19.5-04

TECHNICAL BULLETIN

Squeaks & Rattles – Noise from Console Veneer & Trim – Install Anti-squeak Tape

MODEL 1995 MY
Sedan Range
VIN 720001-740940

ILLUSTRATION 1

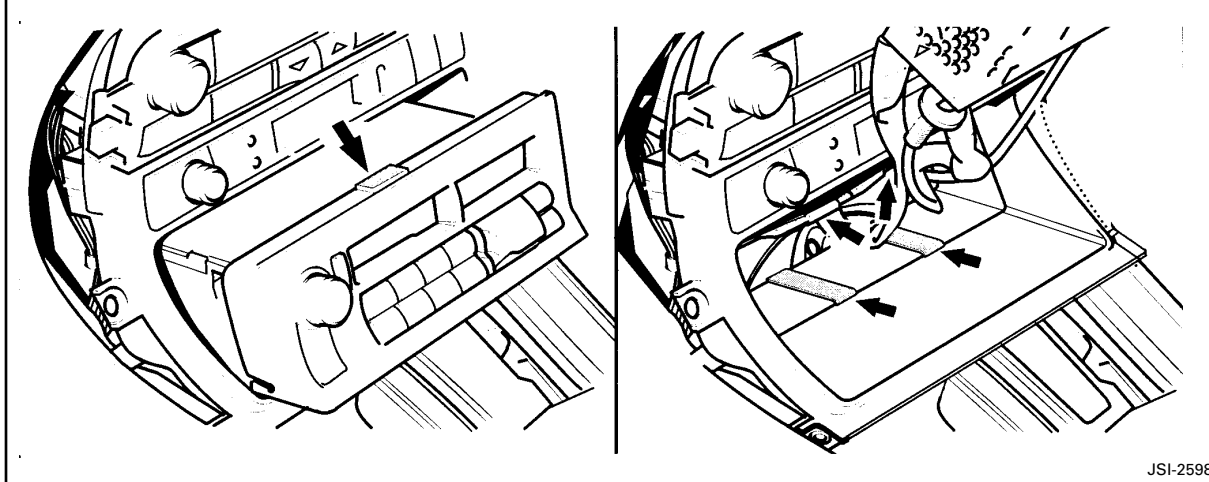
The noise can be eliminated by applying anti-squeak tape to the console veneer panel and a foam pad to the radio fascia.

The foam pad was introduced in production beginning with VIN 736365 and the anti-squeak tape with VIN 740941.

12. Depress the clips and pull out the radio using care not to damage the surrounding area. It is not necessary to disconnect the radio.
13. Cut a 10mm x 20mm piece of closed cell foam pad and apply it to the top edge of the radio fascia behind the front lip (Illustration 1).
14. Hold the cardboard in place and reinstall the radio.
15. Reinstall the console switch panel using care not to pinch the harness wires.
16. Apply 5mm wide anti-squeak tape to the left, right and front outer edges of the console veneer panel (Illustration 2). Do not apply tape to the front outer edge.
17. Apply 5mm anti-squeak tape to the inner edge of the panel (Illustration 2). Do not apply tape to the inner edge of the J-gate opening.
